**ATTACHMENT: RESIDENTIAL ZONES - DCP ASSESSMENT**

## ATTACHMENT B – DCP ASSESSMENT (RESIDENTIAL ZONES)

Extract from ground floor plan and perspective – screen locations fronting Beach Road.

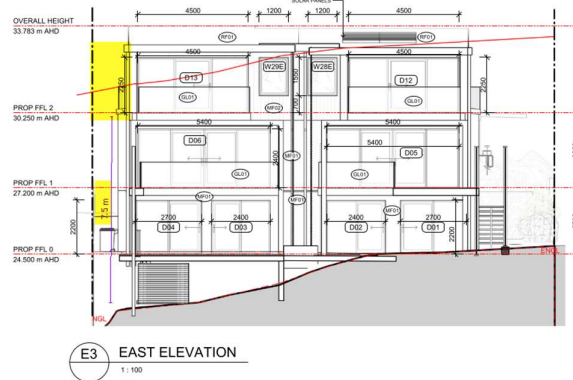
<b>2.2 Setbacks</b>						
<b>For Lots 2500-5000m</b>						
P1	A1. Front 7m, (30m unsealed), Side 5m, Rear 5m		<input type="checkbox"/>	<input type="checkbox"/>	<input checked="" type="checkbox"/>	
<b>For Lots &lt;2500m2</b>						
<b>Front Setback</b>						
P2	A2.1 Dwelling- 20% Avg & no smaller than existing		<input type="checkbox"/>	<input checked="" type="checkbox"/>	<input type="checkbox"/>	<p><b>Dwelling:</b> <b>Required:</b> 5m i.e. adjacent dwellings allow front car parking and maneuvering areas as evident on aerial photographs. Measurement by Council on survey plan of No. 217 Beach Road measures garage setback of 5m: <b>Proposed:</b> 1.5m (car park/building vertical wall screens)</p>

*Extract from site analysis plan with adjoining buildings highlighted:*

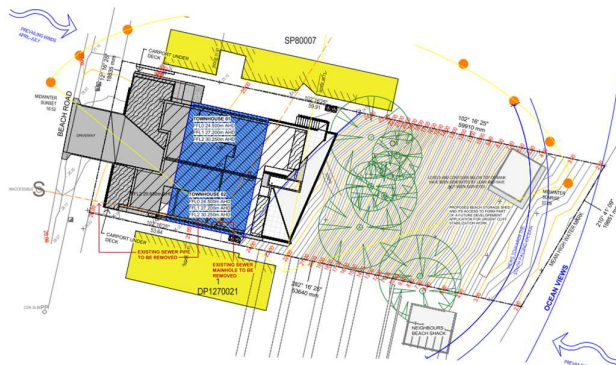
The proposal involves construction of a dual occupancy beyond the top of bank of the cliff for the rear boundary setback. This approach is consistent with the neighbouring properties along this section of Denhams Beach. Denhams Beach is currently not accessible to the public (the access previously available from the north via Council owned land has been subject to cliff instability and has been closed by Council).

The development approved along this section of Denhams Beach relies on an average setback. The submitted plans illustrate the proposal has considered the rear setback in relation to adjoining buildings. It is noted that adjoining buildings project beyond the cliff top edge.

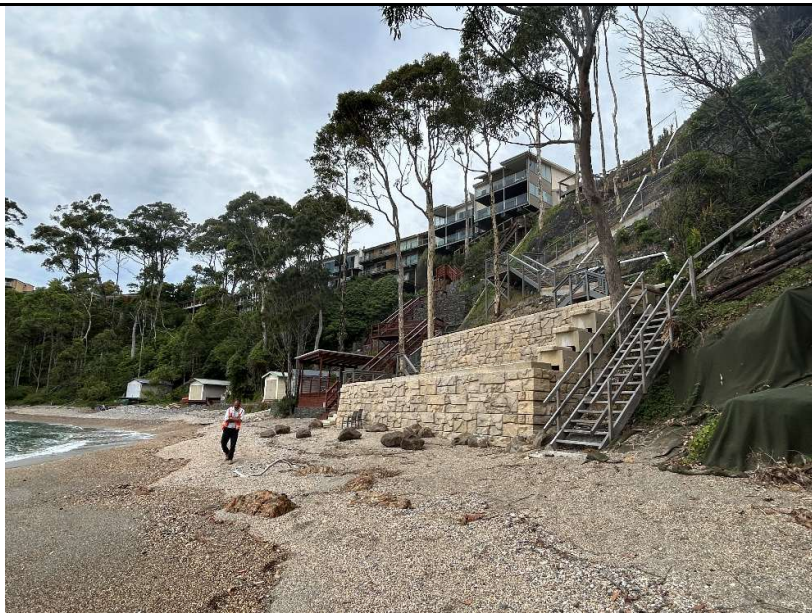
4.1 Bulk and Scale	P1	A1. Stepped on sloping sites	<input type="checkbox"/>	<input checked="" type="checkbox"/>	<input type="checkbox"/>	<p>The proposal does not step down the block. The design proposes a built form that is higher than the allowable building height that is excavated into the site for the lower ground floor however the proposal involves projection of the built form beyond the cliff top</p>
